RE: Preliminary Plan # 1-06001
South Glen Road

SUBJECT: Preliminary Plan 1-06001
South Glen Road

Re: Phase I Letter of Findings, WSSC Project No. DA4306Z6, South Glen Road

**SUBDIVISION PLAN REVIEW: MNCPPC Development Review Committee (DRC)
Comprehensive Water Supply and Sewerage Systems Plan Issues**

South Glen Road

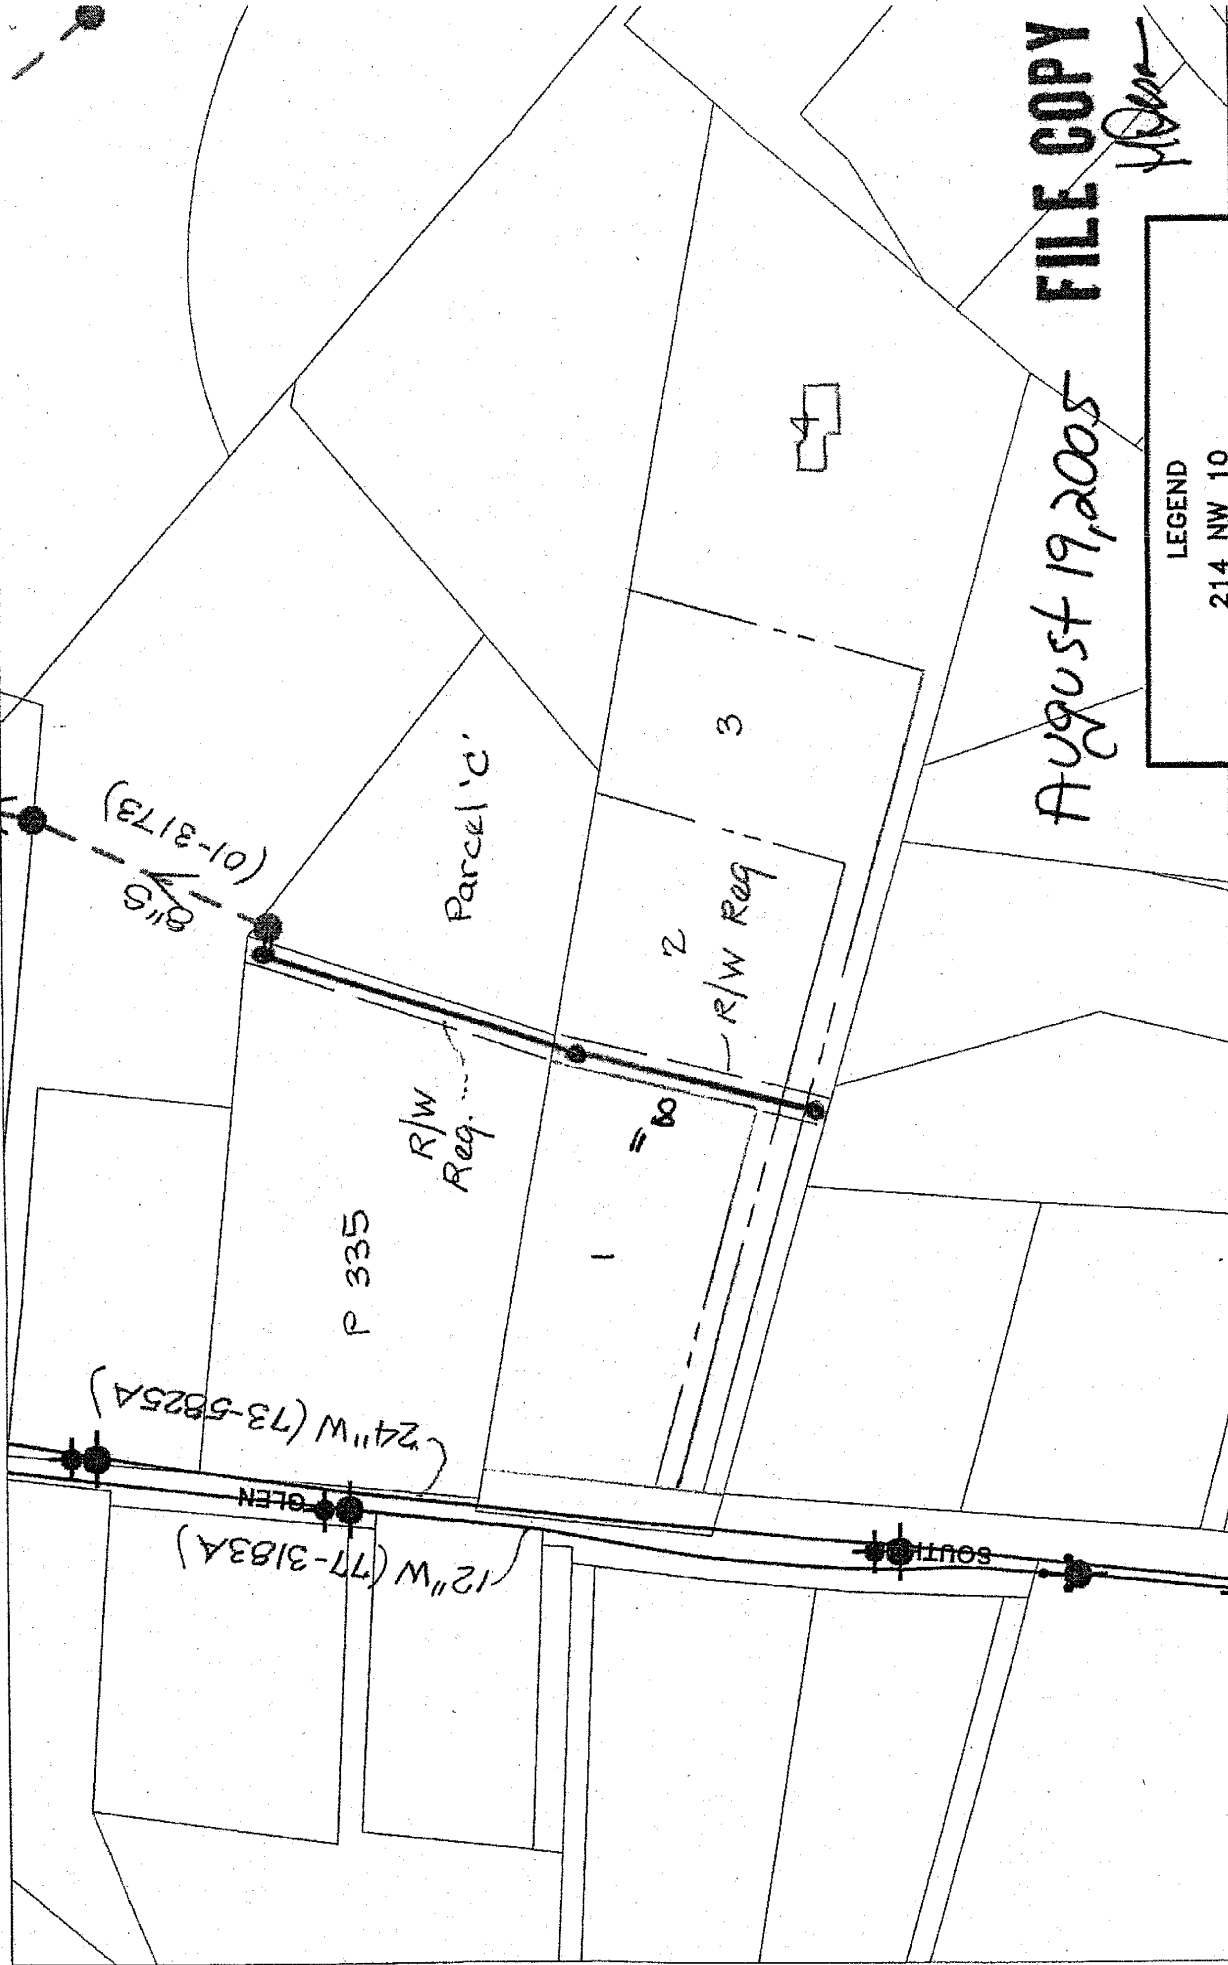
A hydraulic planning analysis has been completed on the South Glen Road project and the project has been conceptually approved. Please refer to the enclosed 200'-scale sketch along with the summary table and list of conditions included in this letter, which provide the results of our analysis.

All sewer is to be gravity and 8-inch in diameter as shown on sketch.

Based on the proposed grading plan, ejector or grinder pump(s) and on-site low pressure sewer are/may be required for service. A registered plumber must install the pumps at the developer's expense.

The proposed sewer main extension will require the acquisition of rights-of-way from other property owners. It is the Applicant's responsibility to obtain these rights-of-way for the WSSC.
